ADDENDUM #1

DATE: April 28, 2025

TAYLOR STADIUM TURF REPLACEMENT

PROJECT NUMBER: CP252171

CE 4.0

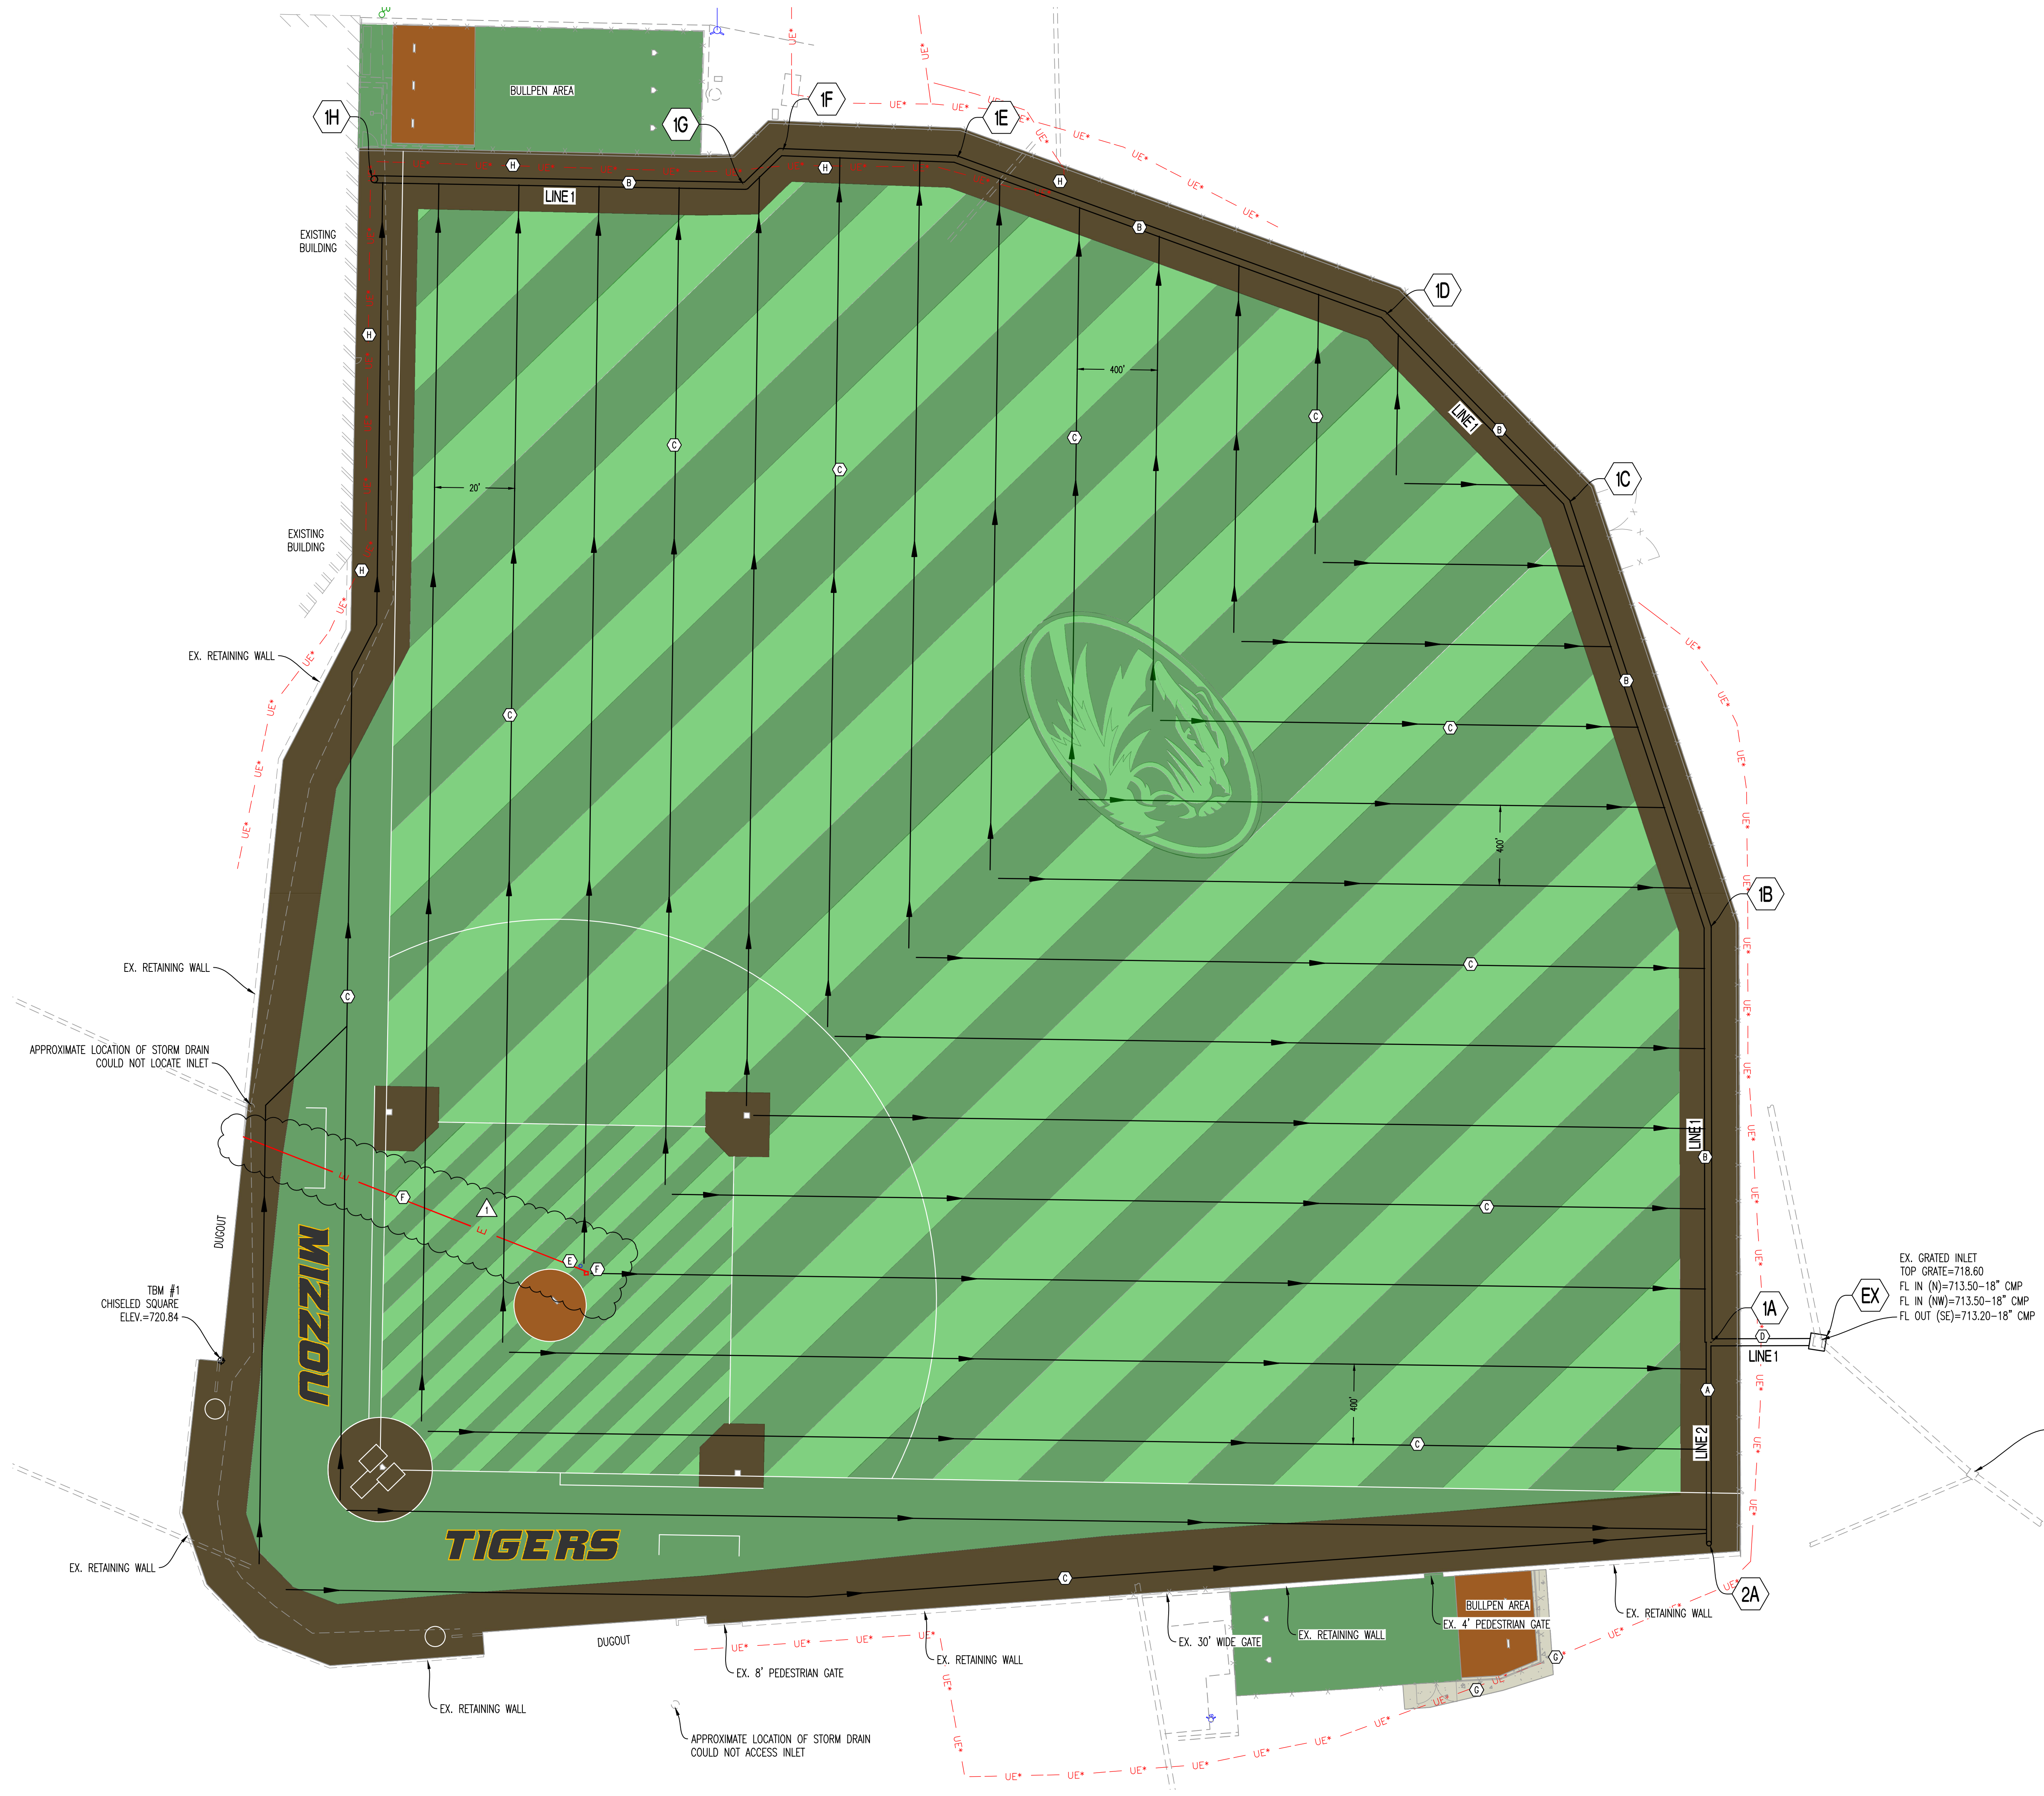
1. SHEET CE 4.0 – Underground Conduit modified to reflect MEP conduit location.
2. SHEET EP101 – MEP Power Plan added.
3. SHEET E501 – MEP Details and Schedules added.

(F)	INSTALL NEW ELECTRICAL BOX. ELECTRIC SERVICE AND CONDUITS TO BE COORDINATED WITH M.E.P. TOP OF BOX SHALL BE INSTALLED WITH TURF TOP AND TOP ADJUSTED TO BE FLUSH WITH SURROUNDING TURF.
